CERTIFICATE OF APPROPRIATENESS

Reviewed by the Houston Archaeological and Historical Commission

Application Date: December 1, 2025 **HPO Fine #:** 2025_0347 **ITEM #:** B12

Proposal: Alteration –Addition, Windows, Porch, Siding

SITE PLAN EXISTING

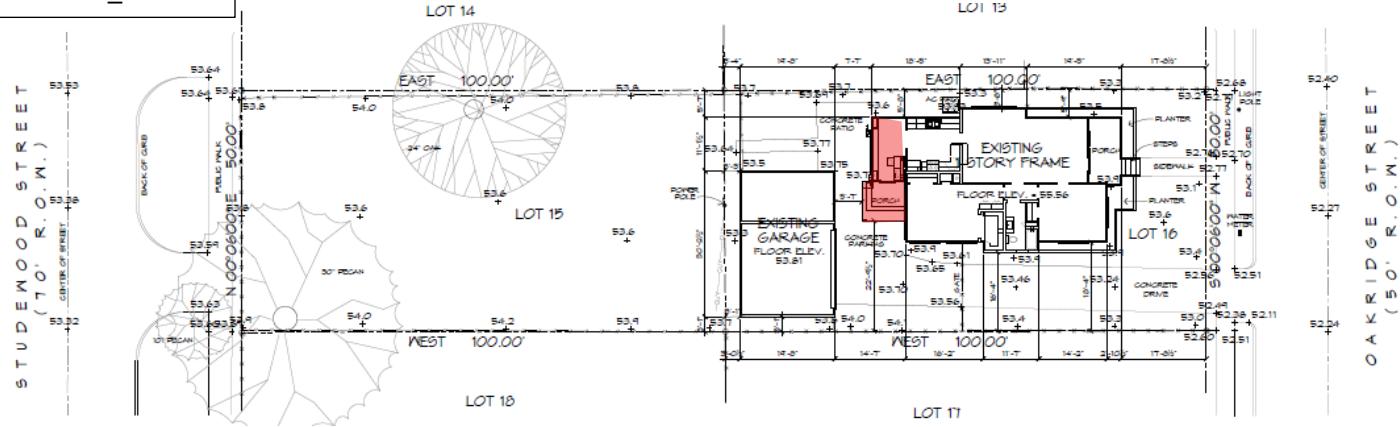
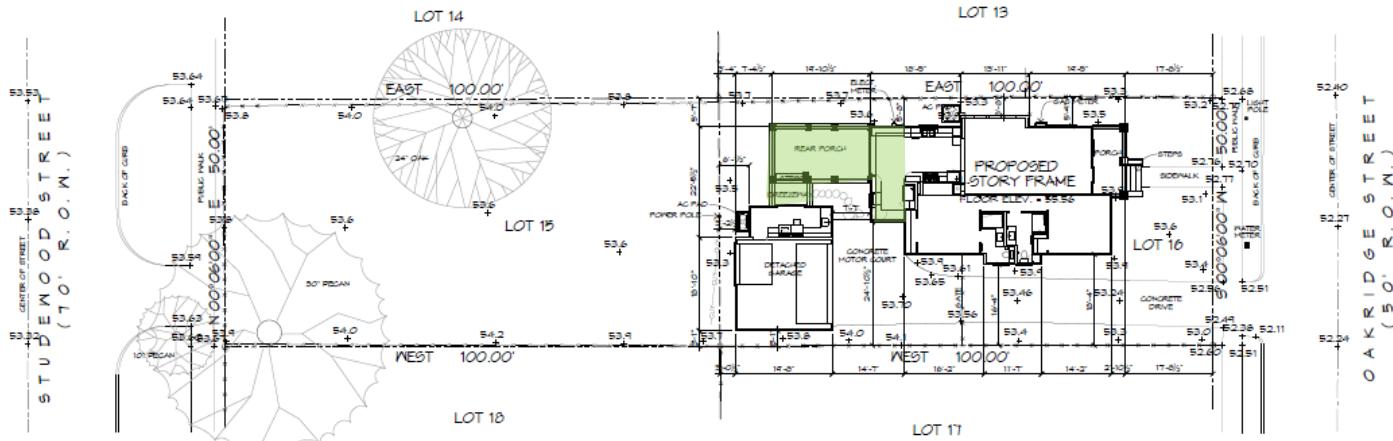
Garage addition
not in scope of
work. See
HP2026_0009.

FLOORPLAN

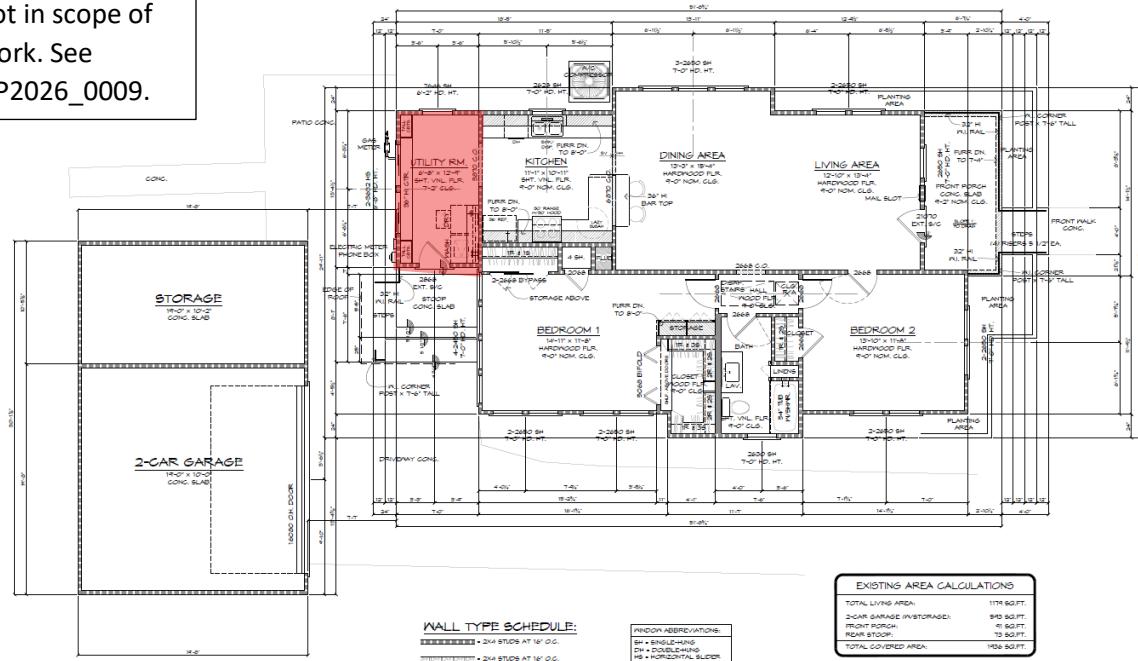
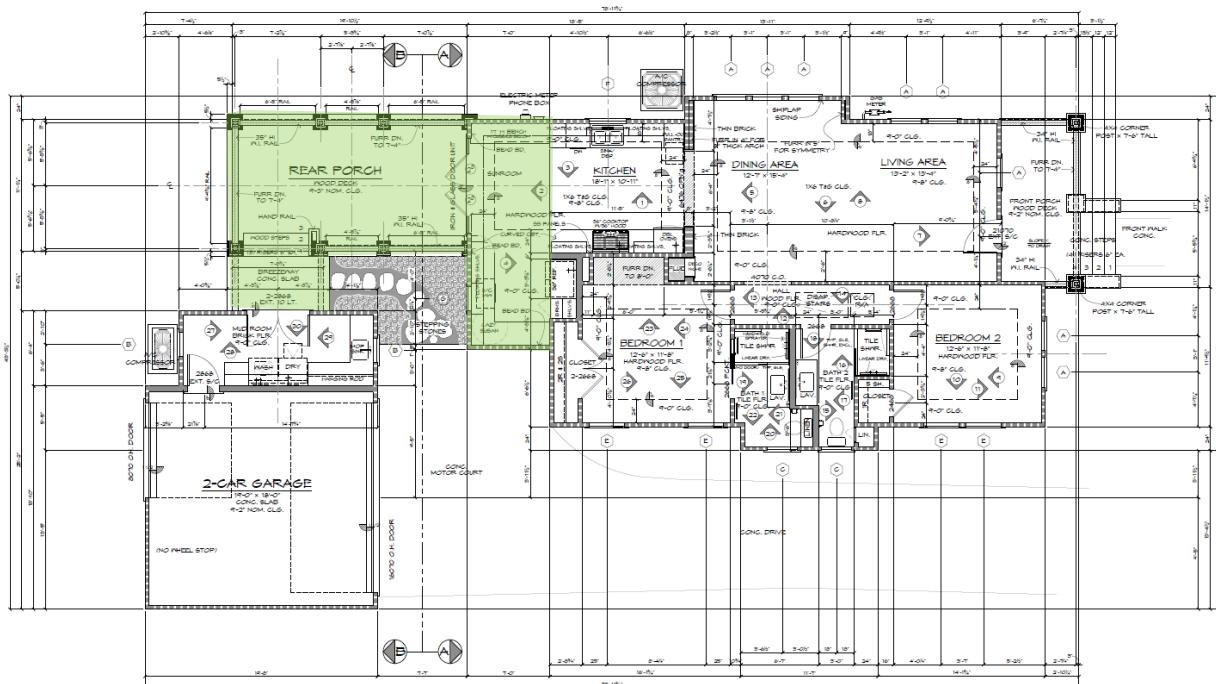
Garage addition
not in scope of
work. See
HP2026_0009.

EAST (FRONT) ELEVATION

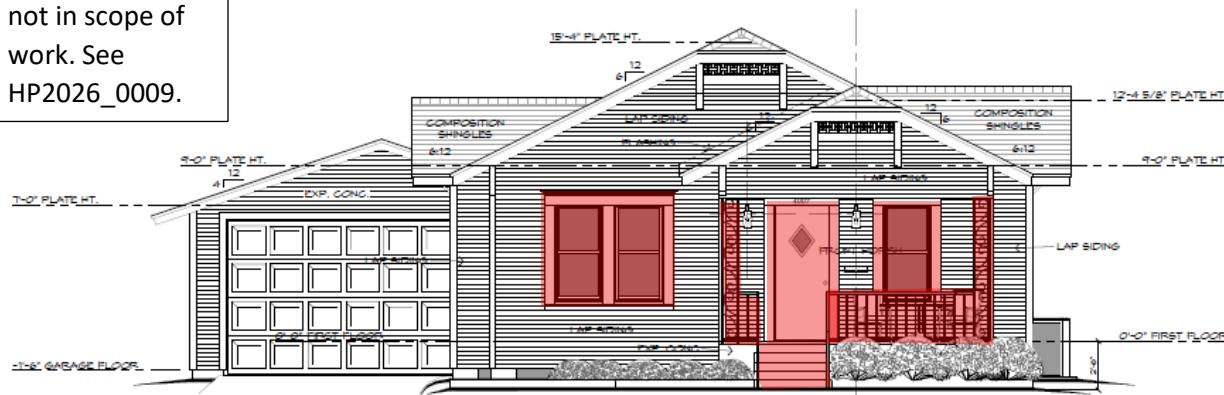
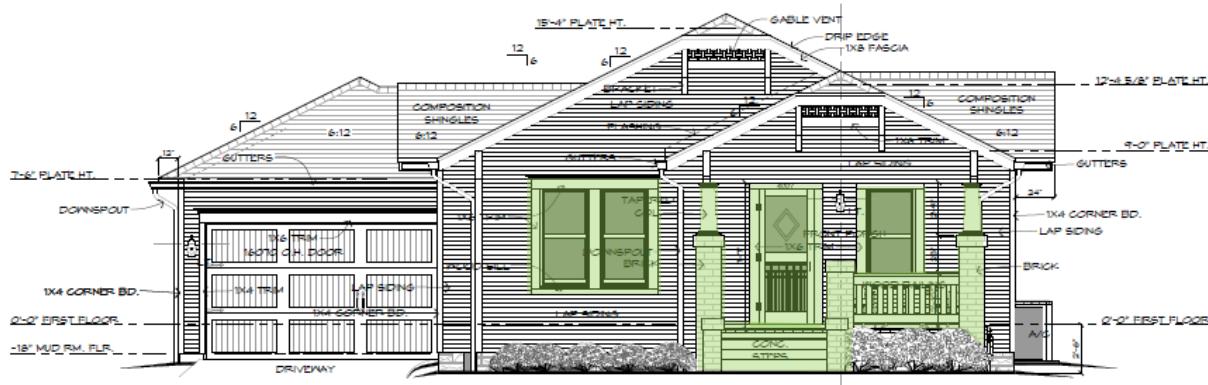
- Front Porch: This property was previously approved for a front porch alteration which is reflected in the proposed front elevation drawings included in this document. Tapered wood columns on brick base, wood decking, wood railing. See HP2025_0045.
- Siding: Existing 117 wood siding is to remain. Repair per existing as needed.
- **Proposed garage alterations** can be found in separate document **HP2026_0009**.
-

SOUTH (LEFT) ELEVATION

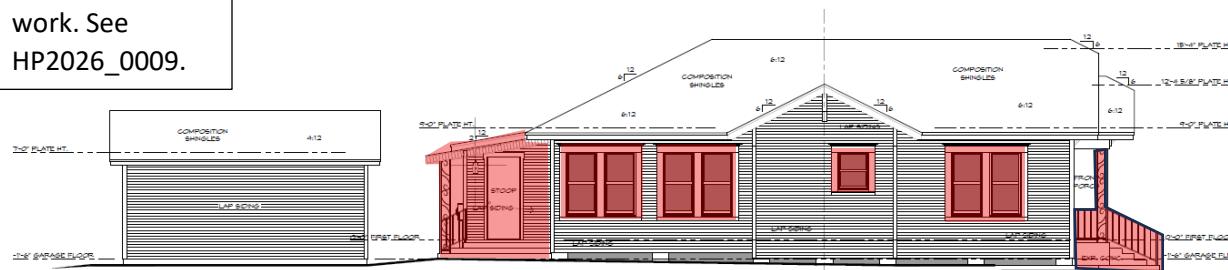
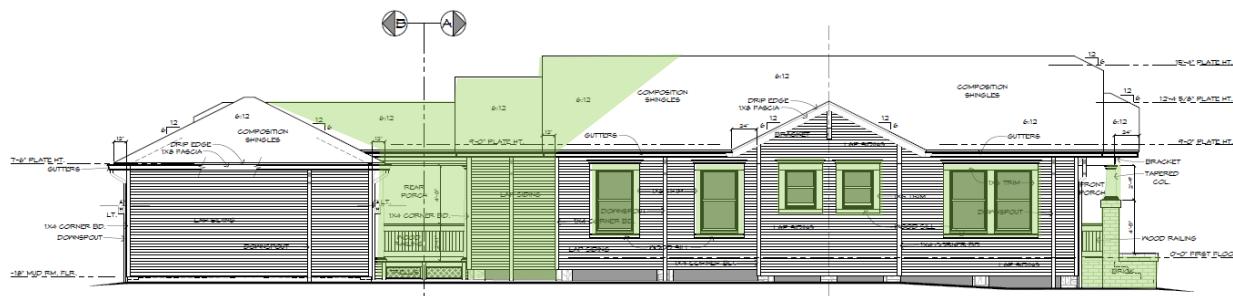
- Windows throughout the building have been replaced over the years with vinyl windows. Two window openings on the south (left) elevation towards the rear will be changed to single windows and one small window towards the center of the elevation will be added.
- Two window openings on the north (right) elevation towards the rear will be changed to two horizontal windows with privacy glass.

ALL NEW WINDOWS are to match existing and be **Inset and Recessed**.
